Comment Report

Project Name: 2022-02 Uniform Modeling Framework for IBR | Standard Authorization Request

Comment Period Start Date: 5/17/2024
Comment Period End Date: 6/24/2024

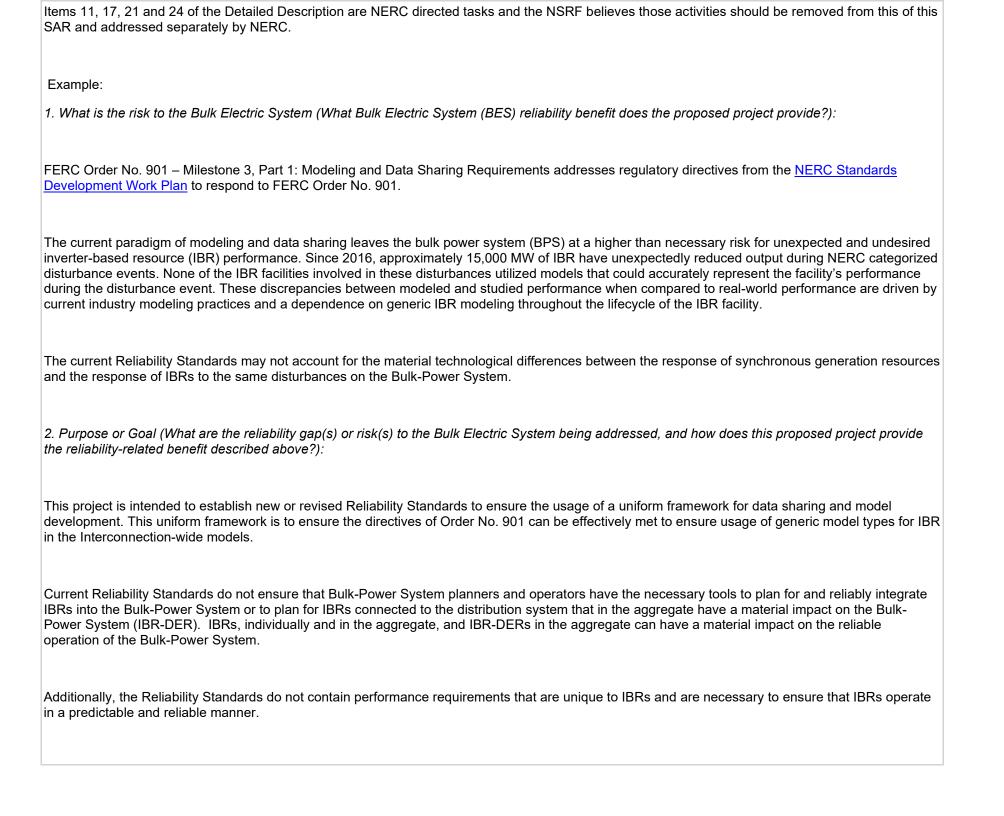
The Risk, Purpose and Detailed Description should be evaluated to provide concise descriptions without the additional Order 901 language. (see below for example)
